9 April 2021

Waipa District Council
Private Bag 2402
Te Awamutu 3840

RE: 3Ms of Cambridge GP Limited – Response to section 92 Request for Further Information

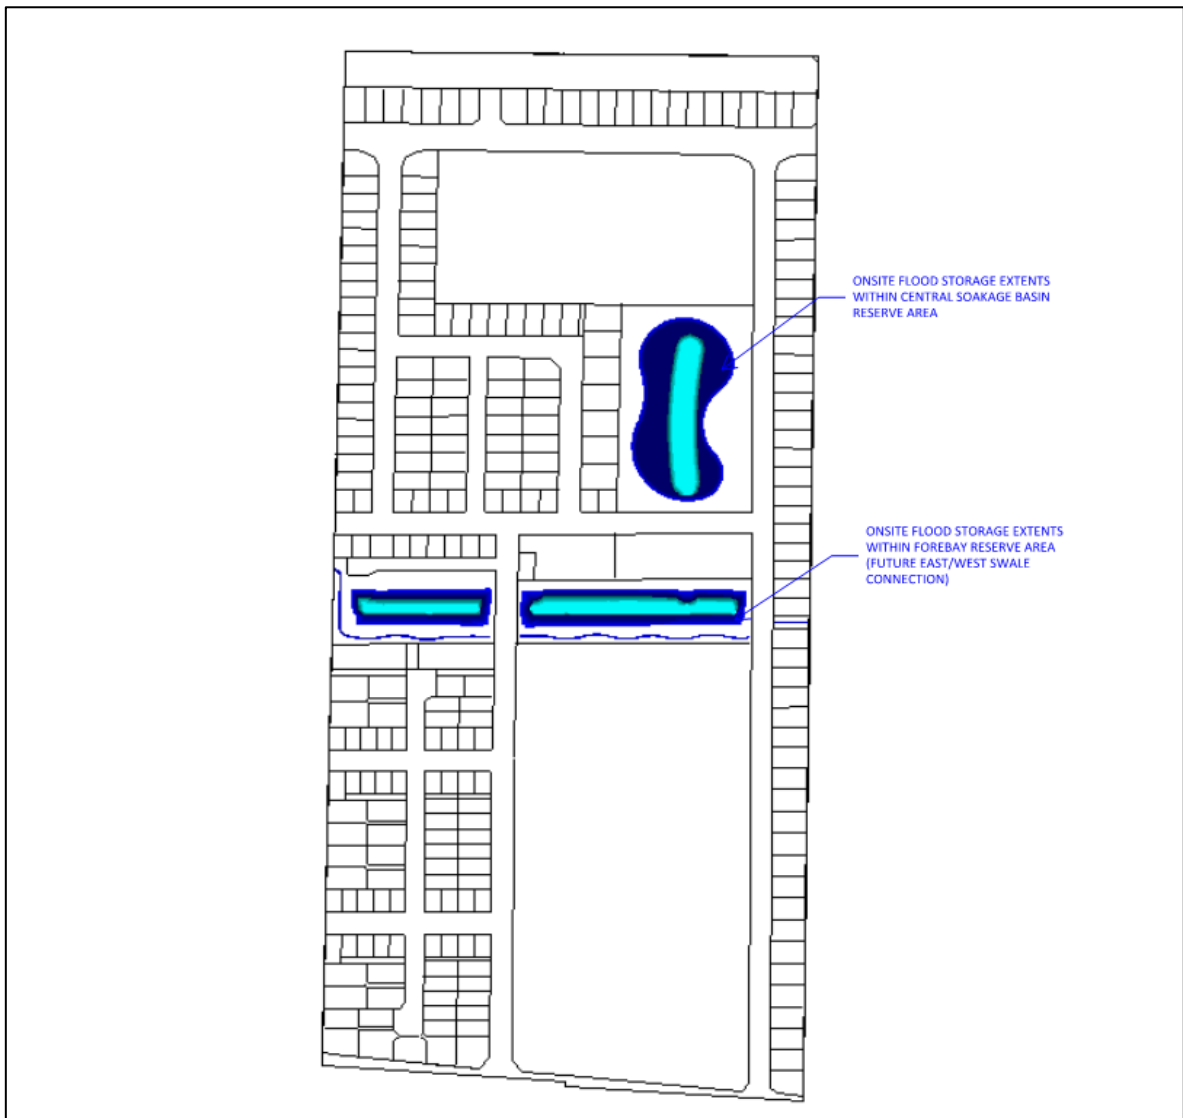
Question 1: *Please provide and demonstrate technical engineering assessment proving the onsite stormwater management will have sufficient capacity to protect the surrounding locality from potential for stormwater flooding.*

The stormwater solution provided within the 3Ms development site has been sized to provide flood storage to accommodate a 24hr/1% AEP storm event within proposed stormwater reserve areas, including more than 300mm freeboard to adjacent areas. The following table provides an assessment of runoff volumes generated by the development.

The following diagram shows the extent of flooding within the proposed reserve area during a 24hr/1% AEP storm event demonstrating there is sufficient capacity to manage all development runoff within the proposed stormwater system. Please note that the flood storage provided has adequate capacity to retain the full 24hr/1% AEP storm event in the event of a total blockage within the proposed soakage system.

Figure 1: Road 8 Intersection with Cambridge Road - Graphical Summary of Right Turn Out Performance

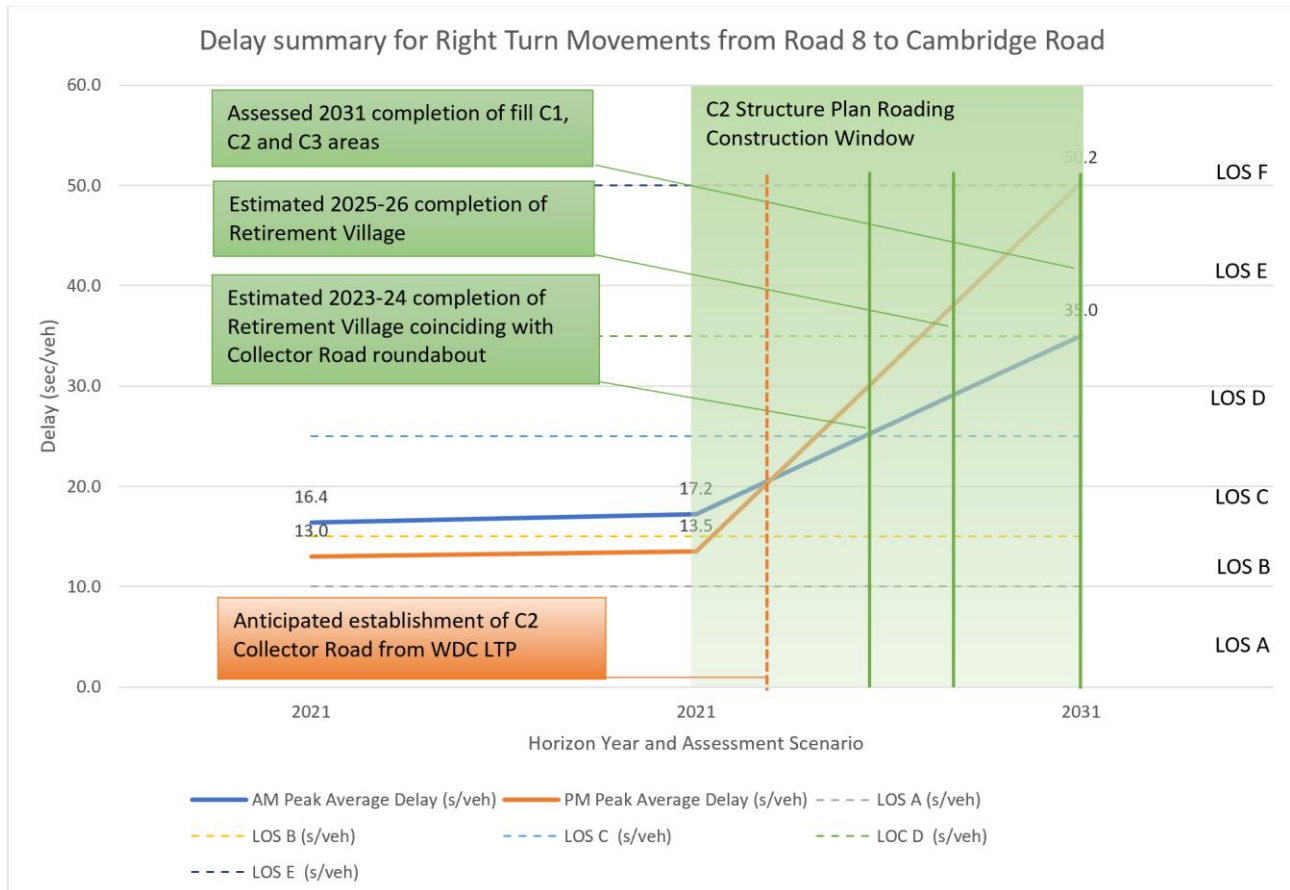
31. The Council remains concerned there is a limit to the traffic that can safely and efficiently use Road 10 and Road 8 without the north/south Collector Road being constructed. Please provide an assessment of this including identification of a limit on the number of lots and development that is appropriate before the north/south collector road and intersection is required.

- Scenario 2 represents full development of the applicant's proposal, as if it were loaded onto the 2021 network. Again, with delay expectations for the right turn out movement in the range 13.5 to 19.7 s/veh (LOS B to C) an acceptably efficient level of performance is expected for this movement;
- Scenario 3 not only introduces 10 years of wider District growth demands, it further loads potential future and full development expectations for the remaining C2 as well as the C1 and C3 growth areas. The resulting change in traffic demands and local road connected network distributions suggests performance for the right turn out movement in the range LOS E (AM peak) to F (PM peak). In this regard, it is evident the applicant's C2 development proposal alone will readily be able to be accommodated.

The graphs for Scenario 3 also represent full future trip demands from these growth cells, the results indicate some peak period delay effects, particularly in the PM period. The orange dashed line on the graphs indicates the expected early introduction, through the LTP, of the C2 Collector Road and Roundabout, which will provide the primary access/egress movement capacity for the C2 area. It can therefore be concluded that the applicant's proposal with respect to both Road 8 and Road 10 intersections will perform acceptably at the level of development intensity proposed and with the anticipated local road connectivity.

Appendix A: Plan showing the indicative arrangement for the Cambridge Road intersections.

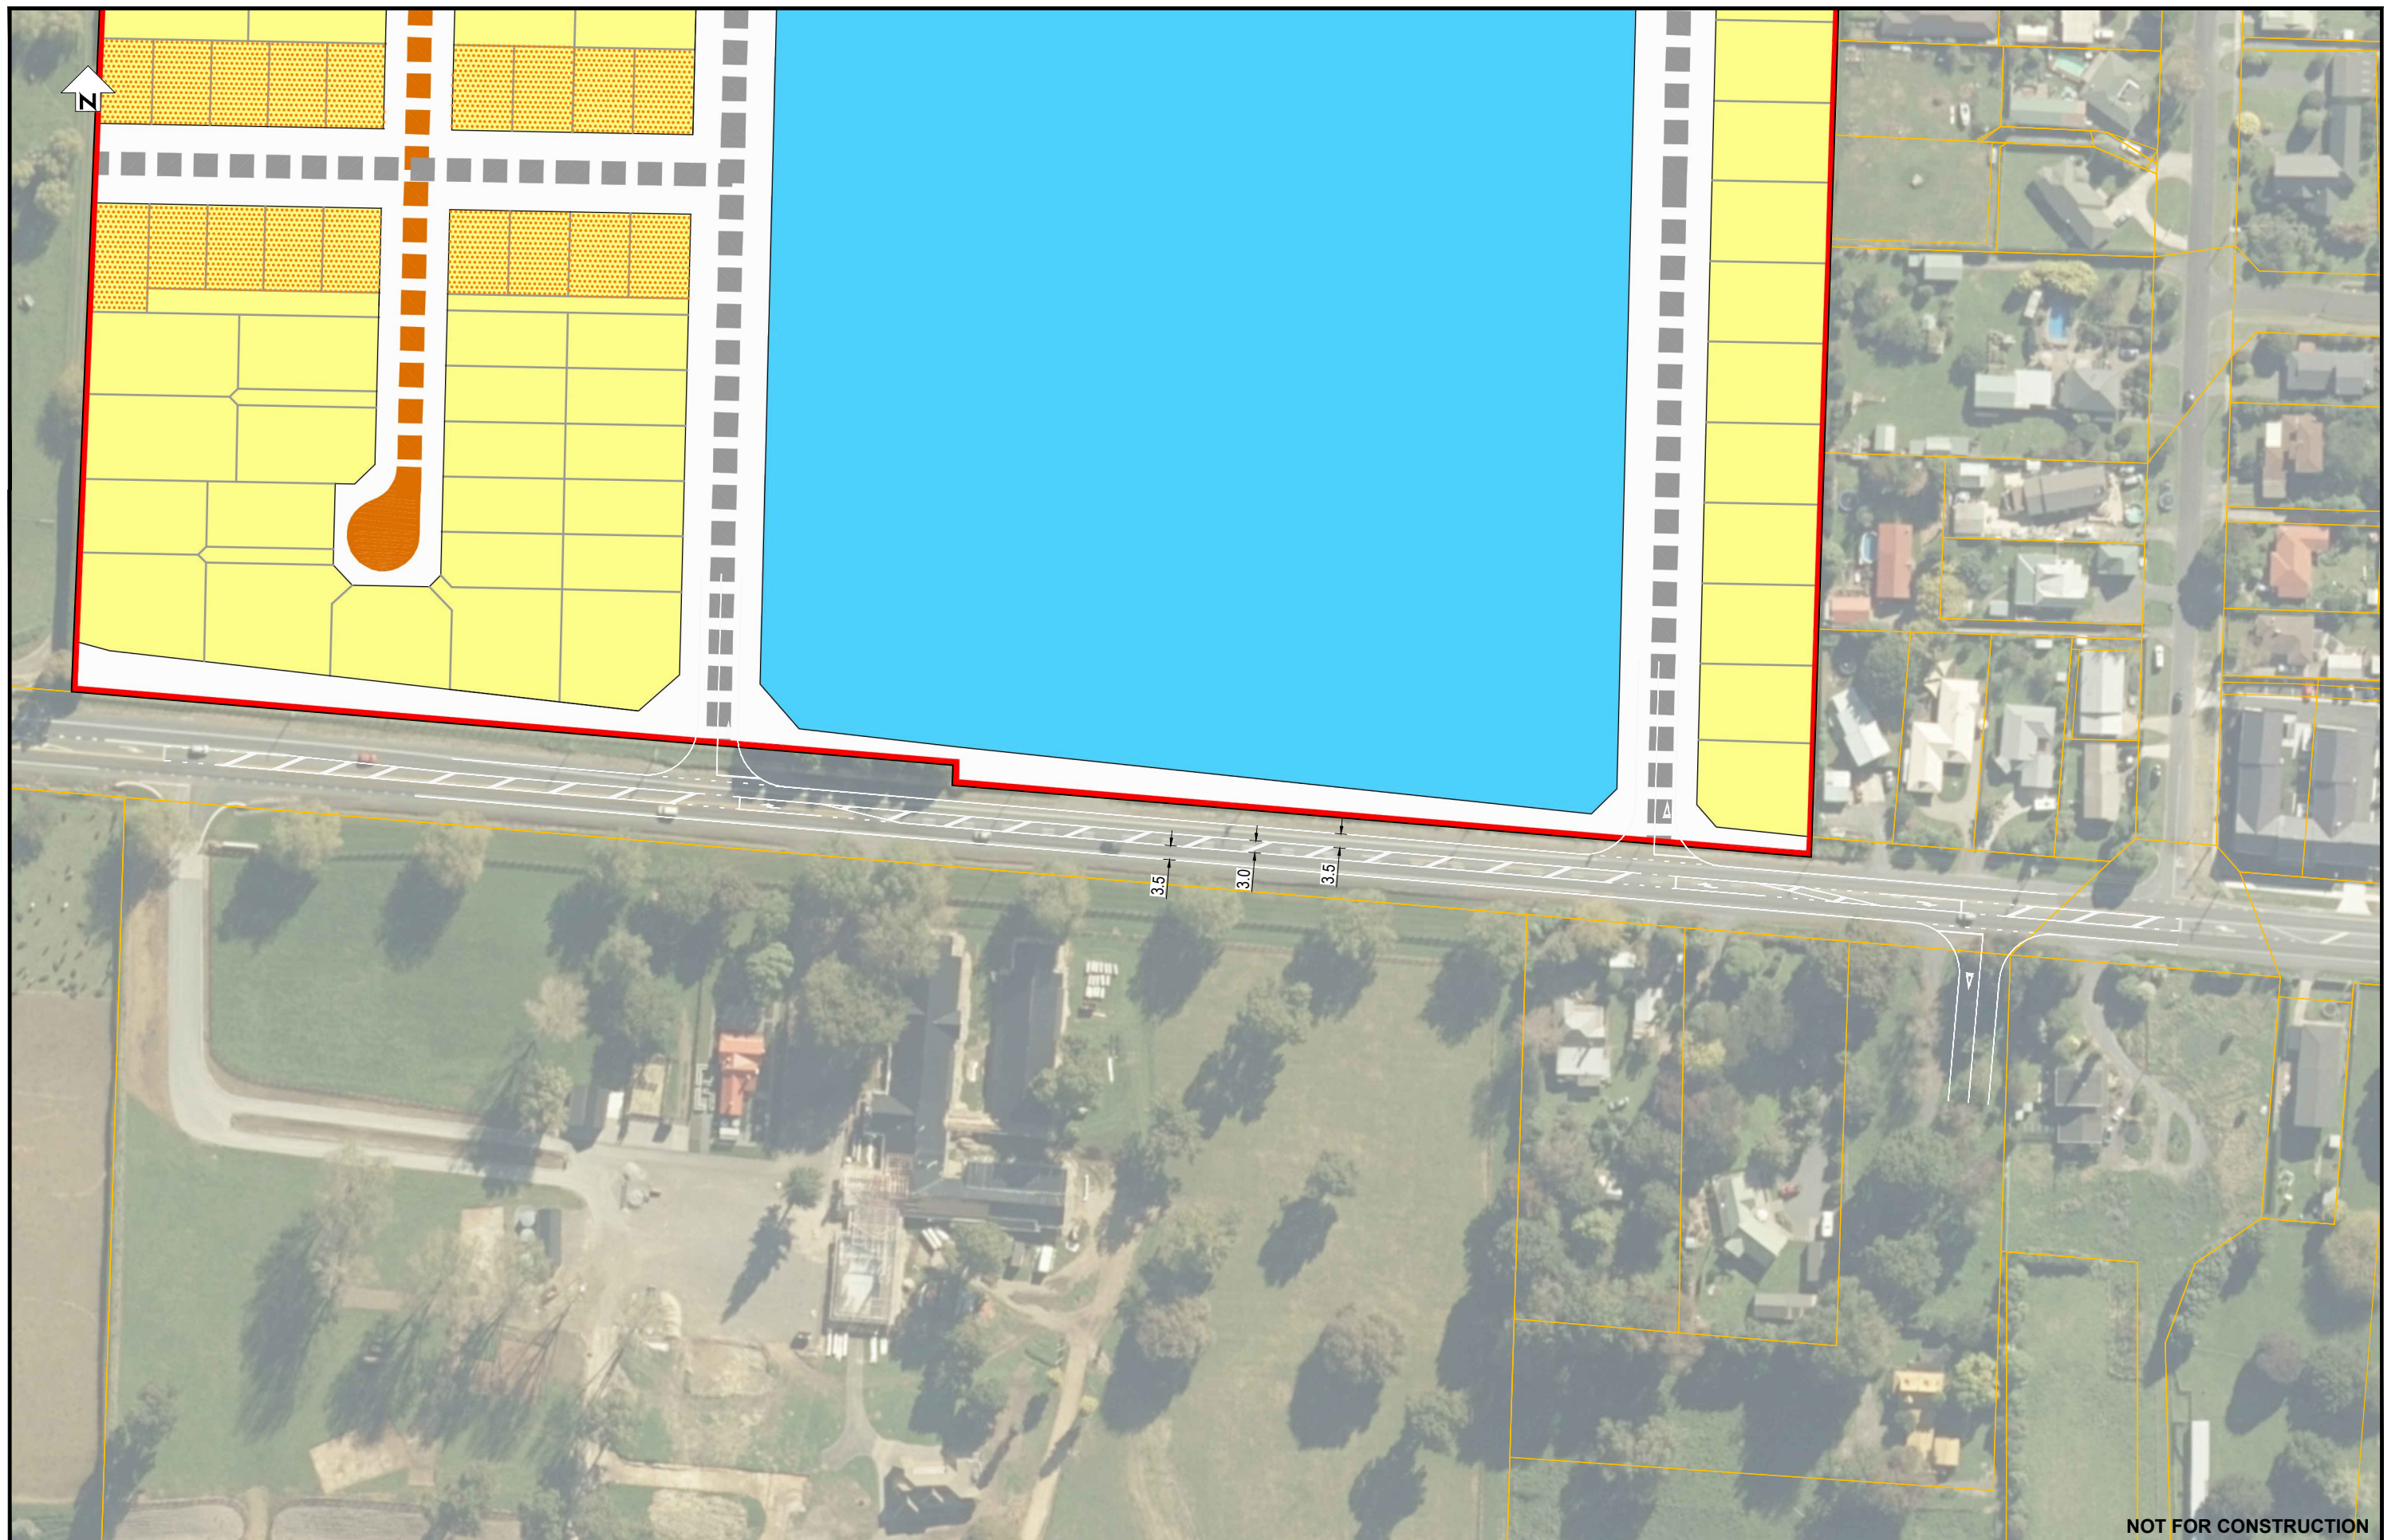
30. Please provide further detail related to design layout, operation and performance of the intersection of Road 10 with Cambridge Road and Chartwell Properties intersection on the opposite side to prove it will operate safely and efficiently. This may require traffic engineering support.

A plan has been prepared showing the detailed design layout of the Road 10 and Chartwell Properties intersections with Cambridge Road (**Appendix A**). The plan extends west to include the proposed Road 8 intersection with Cambridge Rad. By way of a summary, the plan shows the following:

- An extension of the existing central painted median west across the site frontage to provide for continuity and integration of the proposed Road 8 and Road 10 intersections with both the Chartwell Properties as well as the Kelly Road intersections;
- Road 10 is shown safely separated from the Chartwell properties intersection by about 81m;
- Sidra modelling (attached) shows the expected right turn queue on Cambridge Road waiting to access Road 10 to be less than 1.0 vehicle 95th percentile back of queue PM peak at 2031, well clear of the Chartwell Properties access road and adequately providing for drivers to taper into the right turn median waiting area ahead of making the turn;
- The painted median has a width of 3.0m safely providing for vehicles waiting on it clear of the adjacent through traffic lanes;

- The through traffic lanes are shown as continuing to provide for the current level of service at 3.5m with retention of the road shoulder areas.

On the matters of design layout, operation and performance; and based on the assessments described above, it is concluded the proposed location of Road 10 is aligned with the Structure Plan operational intentions and is able to be safely formed and located as proposed.
